H111 UPS3918-1bNAS1

**TECHNICAL BULLETIN**

303-03B / -03C: Engine Cooling

Update Prior to Sale: Engine Coolant Hose Incorrectly Routed

3

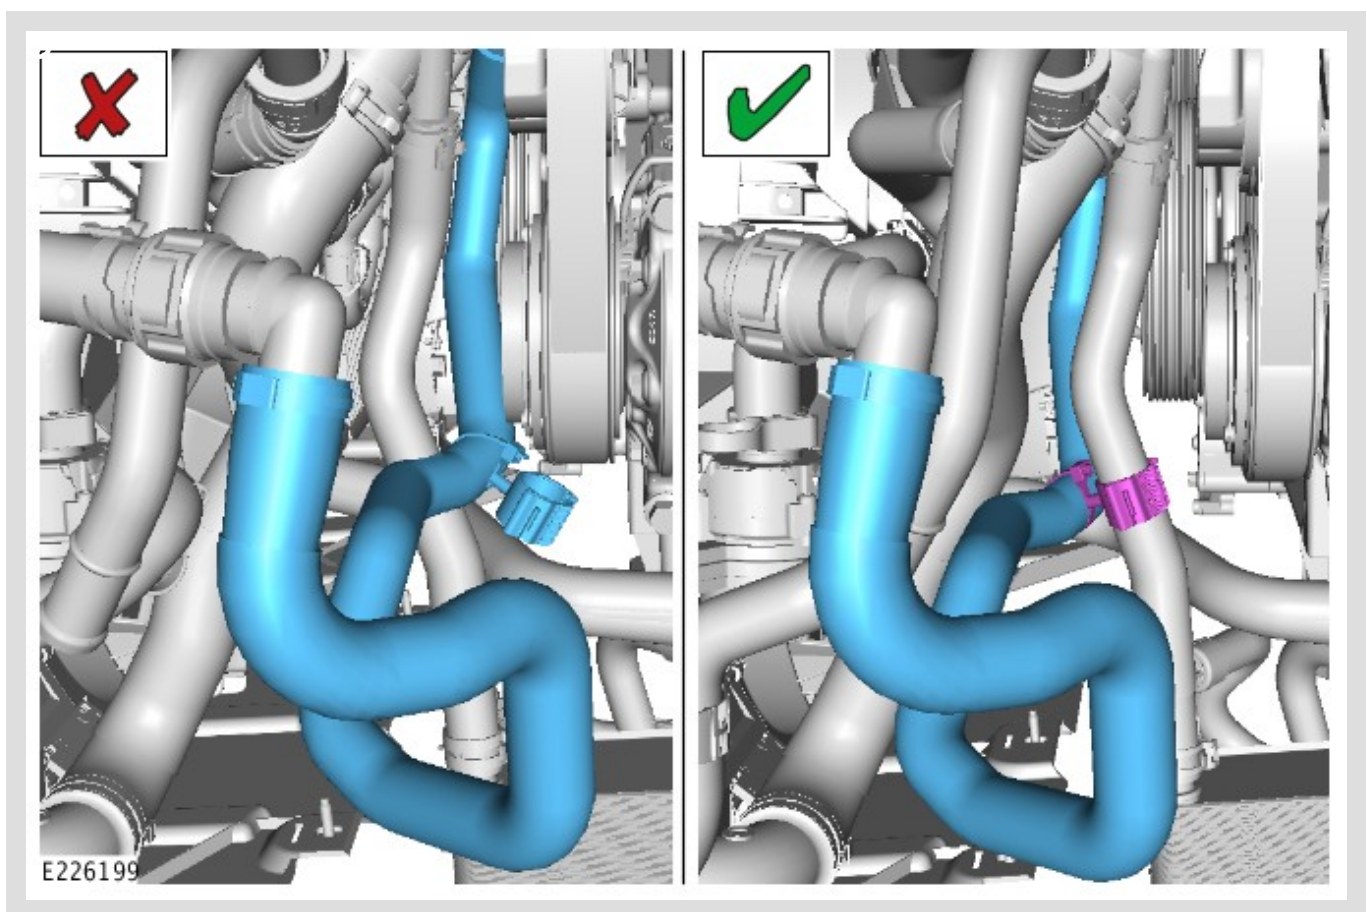
Inspect the engine coolant hose.

- If the engine coolant hose IS installed correctly (✓), go to Step 8.

- If the engine coolant hose **IS NOT** installed correctly (X) and the hose **IS NOT** damaged, go to Step 4.
- If the engine coolant hose **IS NOT** installed correctly (X) and the hose **IS** damaged, continue to hold the vehicle until further instructions are supplied.
  - Do not submit a claim for any vehicle which fails the inspection process and the hose is damaged at this time.

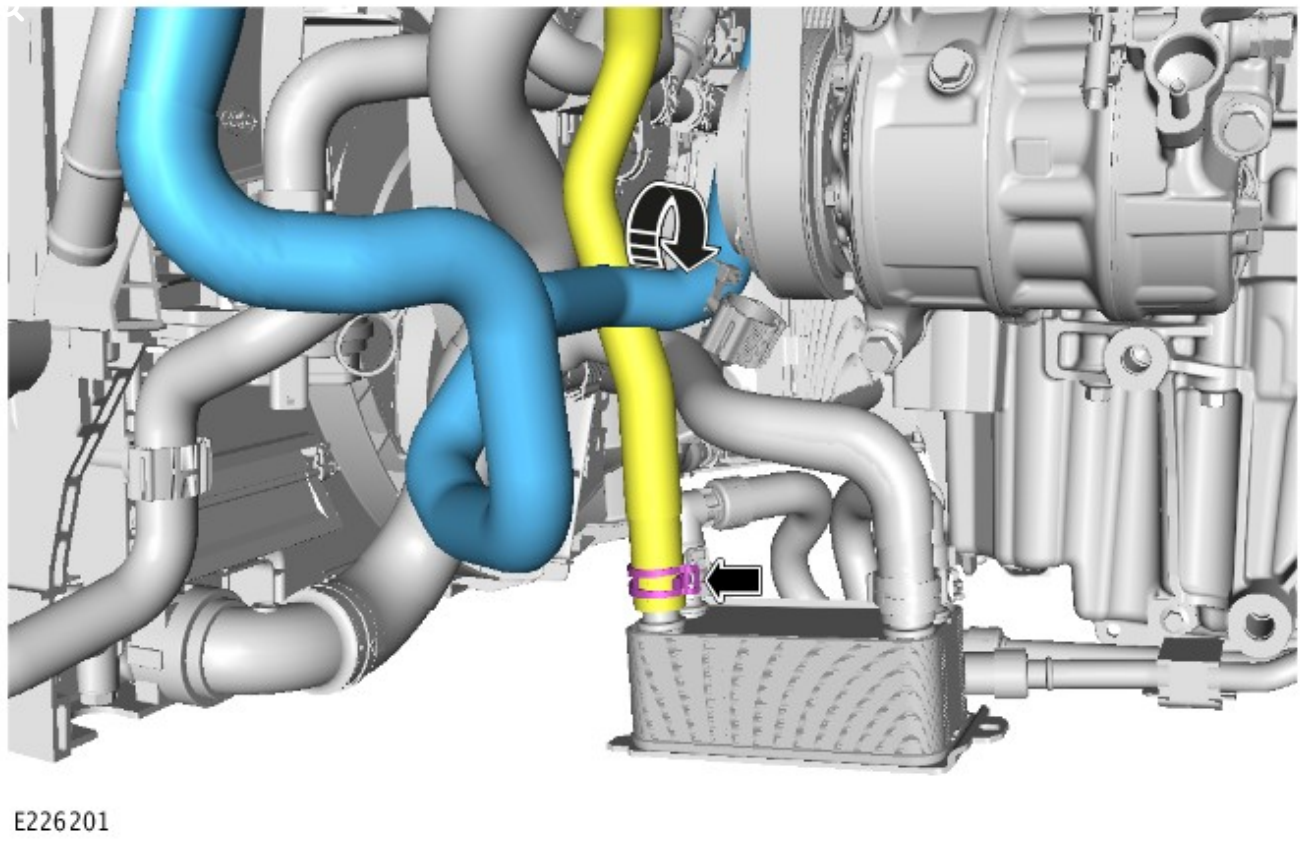
Retain the engine coolant.

Partially drain the engine cooling system (see TOPIx Workshop Manual section 303-03B / -03C: Engine Cooling - Cooling System Partial Draining, Filling and Bleeding).

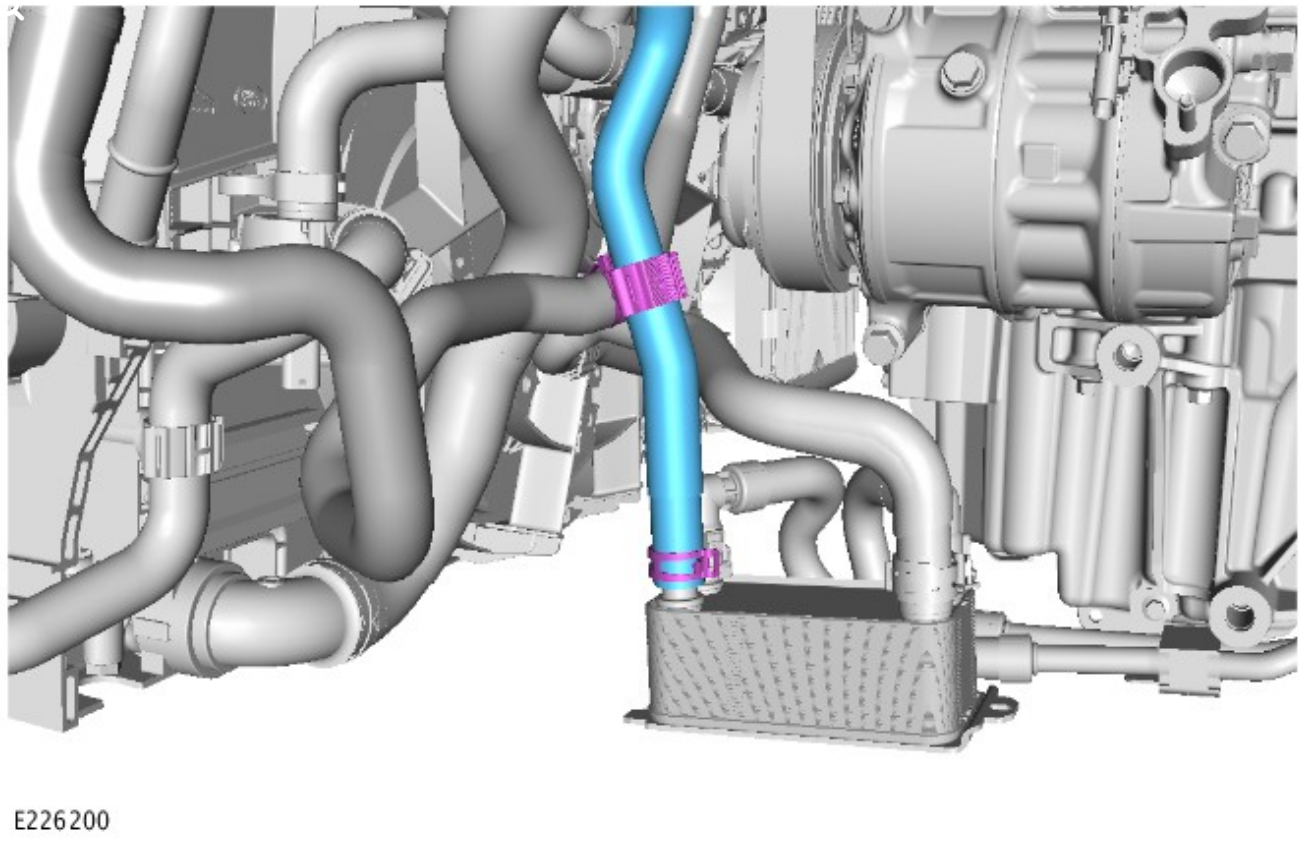
Remove the transmission oil cooler hose fastener and move the oil transmission cooler hose to the correct position.

Install the transmission oil cooler hose in the correct position, making sure to secure the transmission oil cooler hose fastener.
